AMENDMENT OF SOLICITATION/MODIFICATION OF CONTRACT				1. CONTRACT ID CODE	PAGE 1 OF 2 PAGES
2. AMENDMENT/MODIFICATION NO. AMENDMENT NO. 0003		3. EFFECTIVE DATE 7/22/11	4. REQUISITION/PURCHASE REQ. NO.	5. PROJECT NO. (If applicable) 07-0008	
6. ISSUED BY CODE		jsy	7. ADMINISTERED BY (If other than Item 6) CODE		See Item 6
Officer in Charge of Construction MCI-East 1005 Michael Road Camp Lejeune, NC 28547-2521					
8. NAME AND ADDRESS OF CONTRACTOR (No., street, county, State and ZIP Code)				(X)	9A. AMENDMENT OF SOLICITATION NO. N40085-07-R-0008
				X	9B. DATED (SEE ITEM 11) 7/11/11
					10A. MODIFICATION OF CONTRACT/ORDER NO.
					10B. DATED (SEE ITEM 11)
CODE	FACILITY CODE

Project 07-0008, Replace Chiller, Bldgs 59 & 60, Camp Lejeune, NC

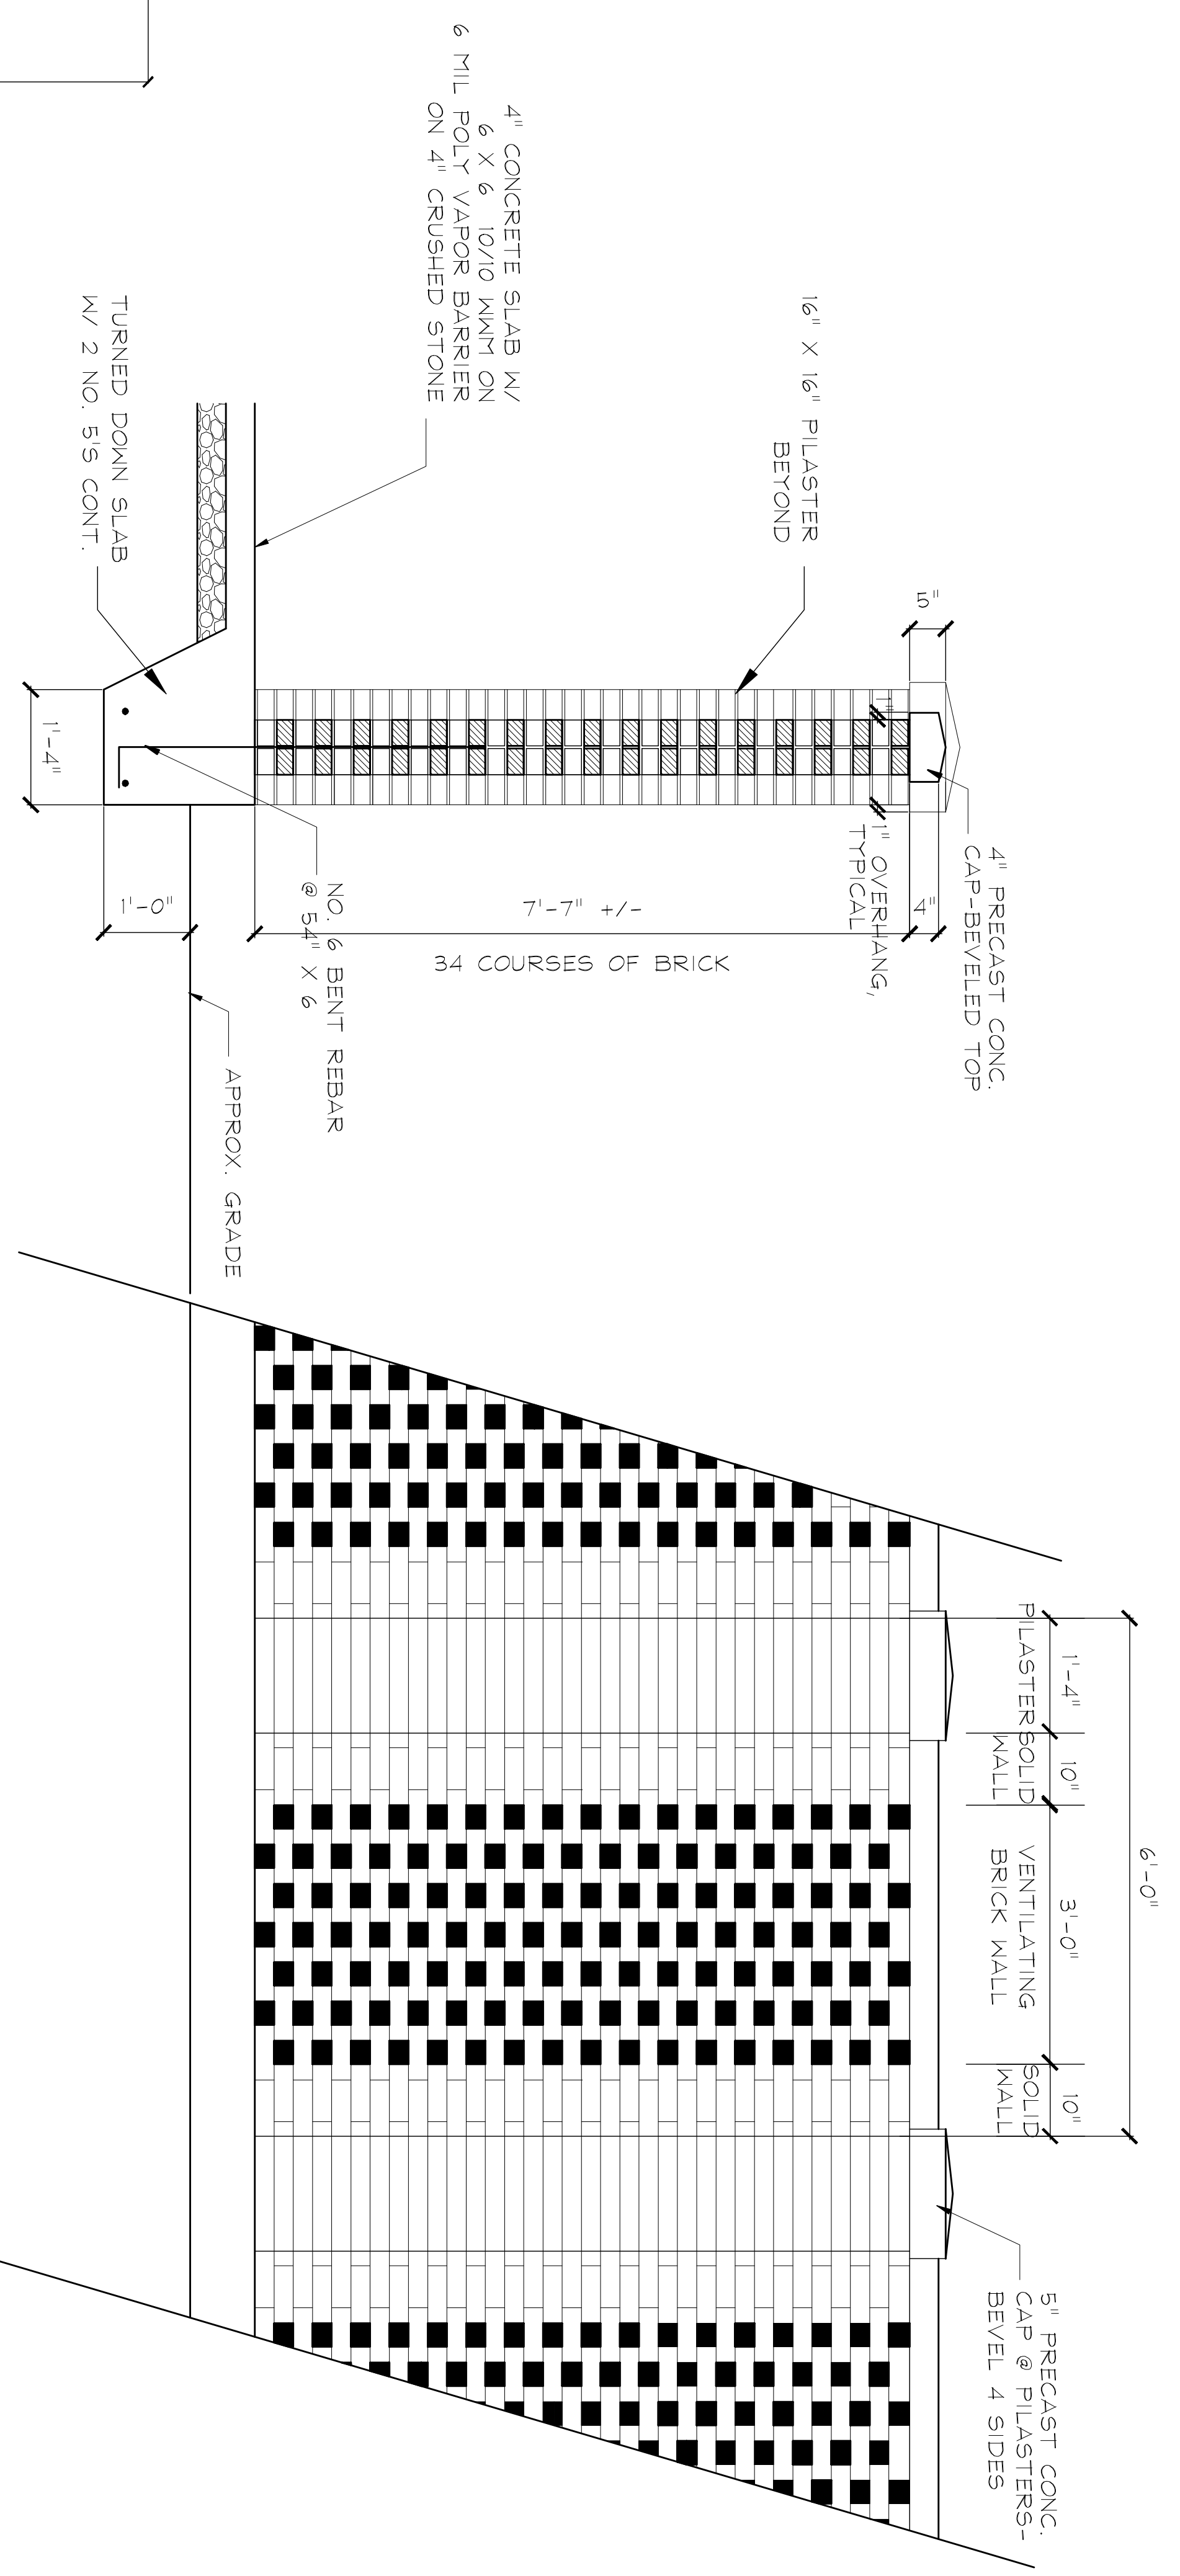
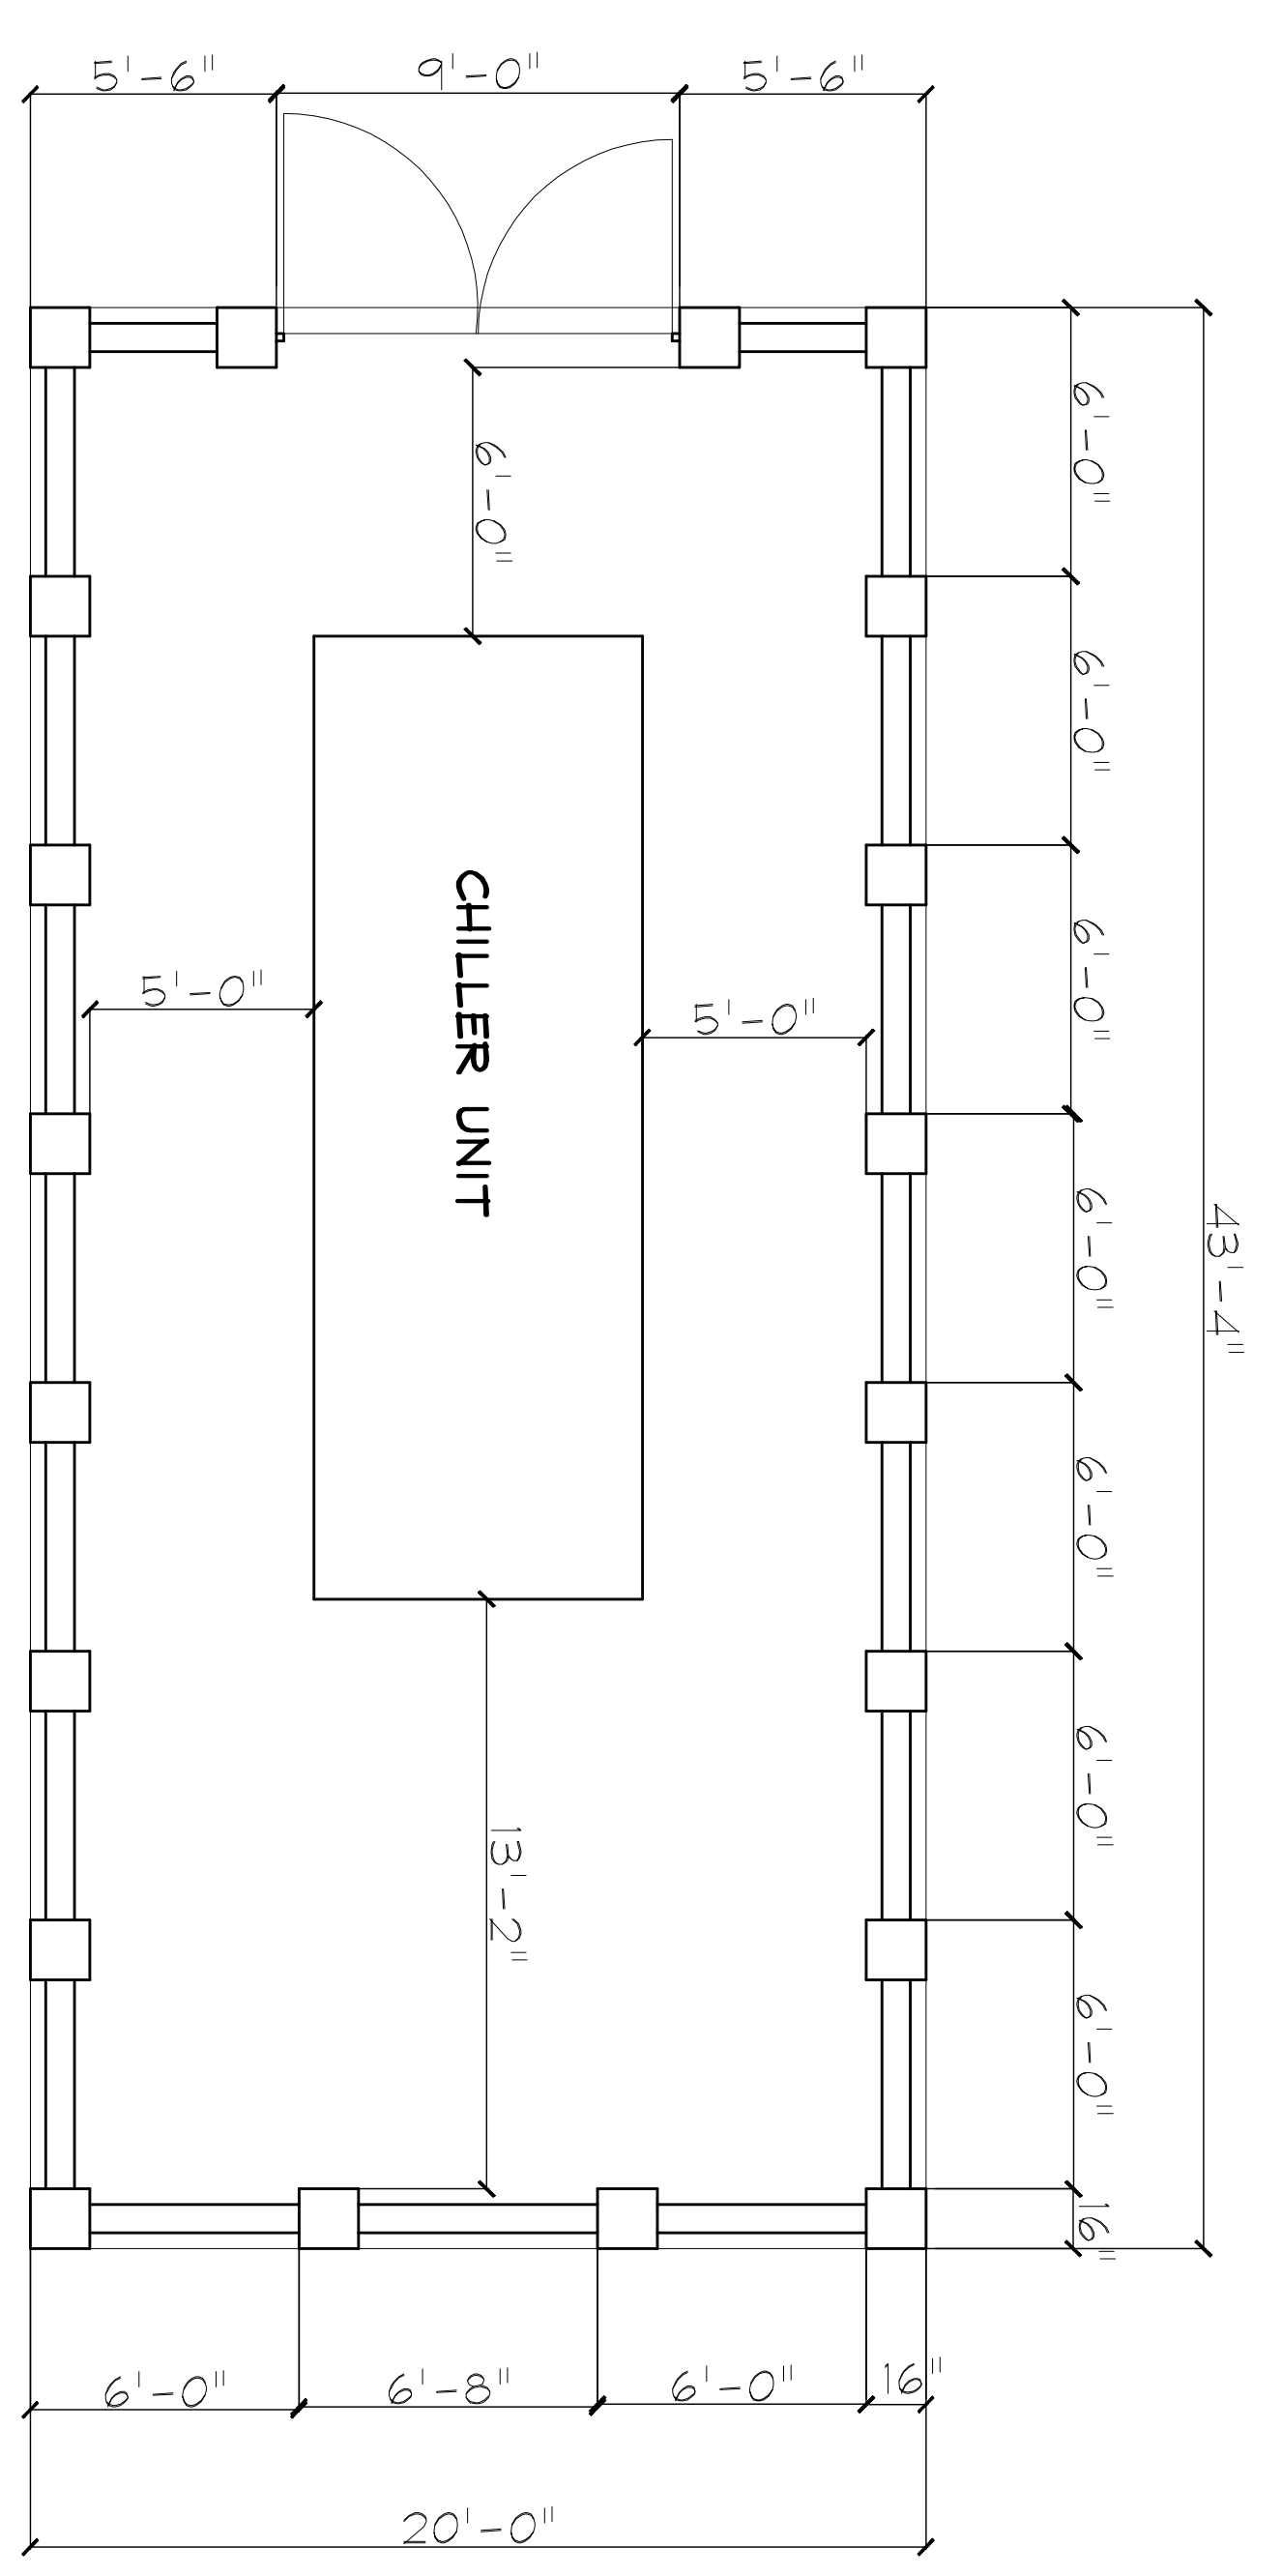
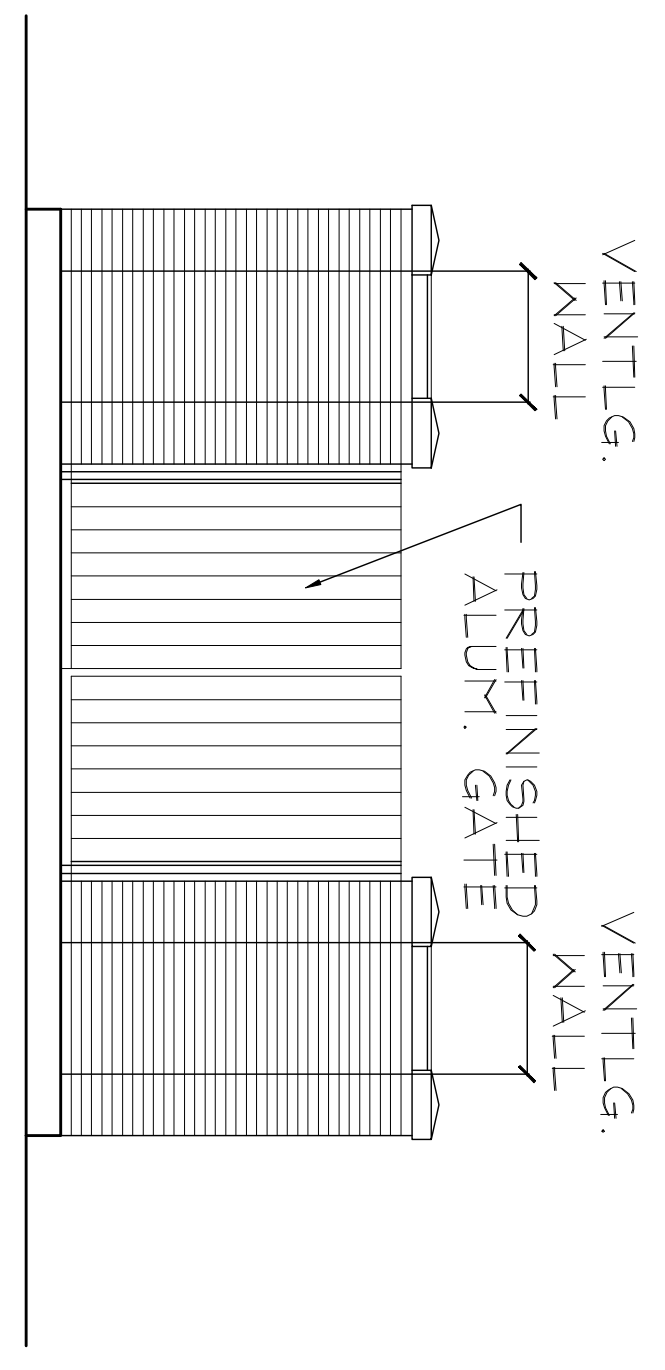
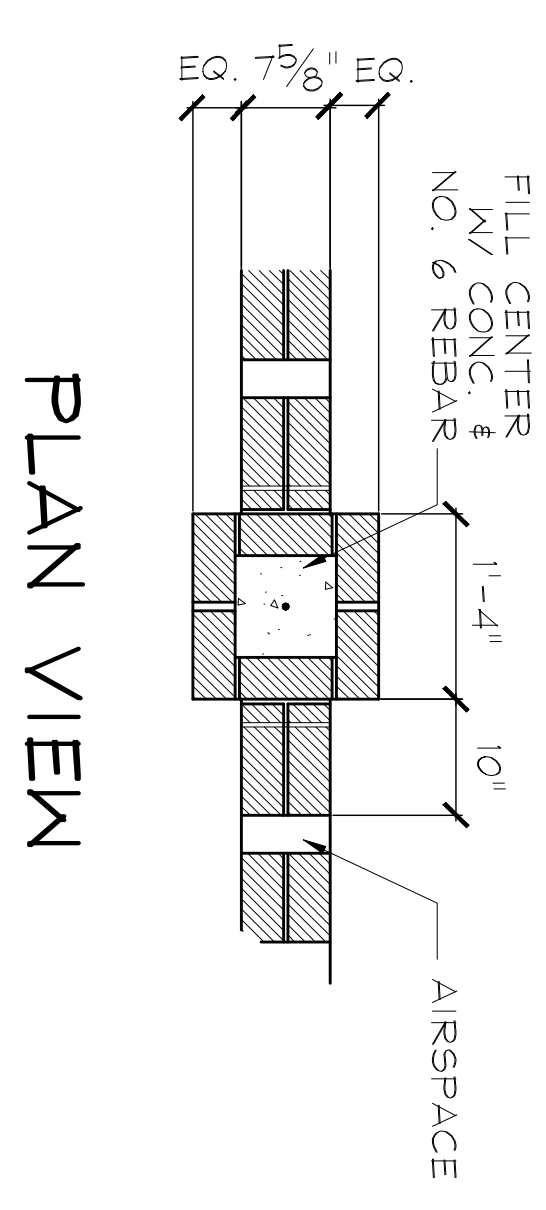
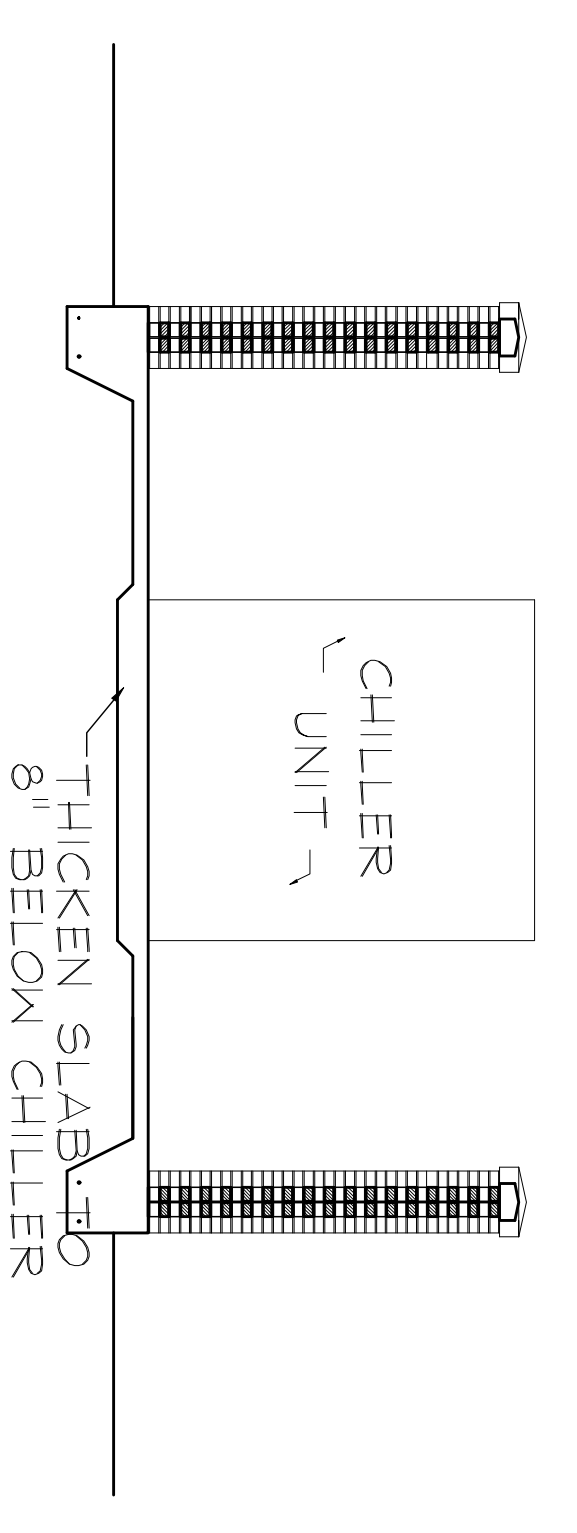
Q: Please provide clarification on the following item(s): Drawing M1 indicates that the New Chiller is located inside of an Enclosure. Is this enclosure new? Drawings do not provide any information on this enclosure.

A: Attached is drawing A-2 for the chiller enclosure. This drawing is hereby incorporated into the RFP (Request for Proposals) dated 7/11/11.
